Navion Service Bulletin No. 103A
July 17, 2009

Subject	Airframe – Fuselage Reinforcing Kit
Effectivity	Serial Numbers NAV-4-002 thru NAV-4-2561
Purpose	Unapproved fuselage beef-up components have been discovered that fail to conform to FAA approved design data. These components, when installed as fuselage structural reinforcements for the installation of the Lycoming GO-435, Continental IO-470P, IO-470C, IO-470H & IO-520B BA BB and higher Horse power and displacement engines installed, fail to meet strength requirements.
Compliance	Mandatory
Description	<p>The Navion Part Numbers for the unapproved parts are 145-31102-XX. Unapproved parts can be identified by one of the following methods:</p> <ol style="list-style-type: none">1. All 145-31102-XX fittings should be stamped out of a single piece of steel. Unapproved parts will have secondary pieces of varying size and shape of made unknown ferrous material welded inside the front flange near the large bolt hole. Suspect parts will also have welded joints of poor quality along the edges of the same flange. Wall thickness different than 0.109” ±0.010” fails to meet strength requirements or conform to approved design data. Inner width

Figure 1. Sample 145-31102-XX fitting suspect part

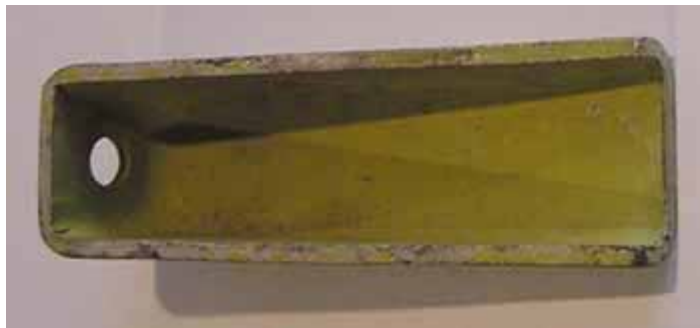
NOTE:	If any part fails to meet strength requirements or conform to approved design data, all parts of the kit are considered unapproved and should be inspected for conformity. Kits which fail to conform should be replaced or field approval obtained.
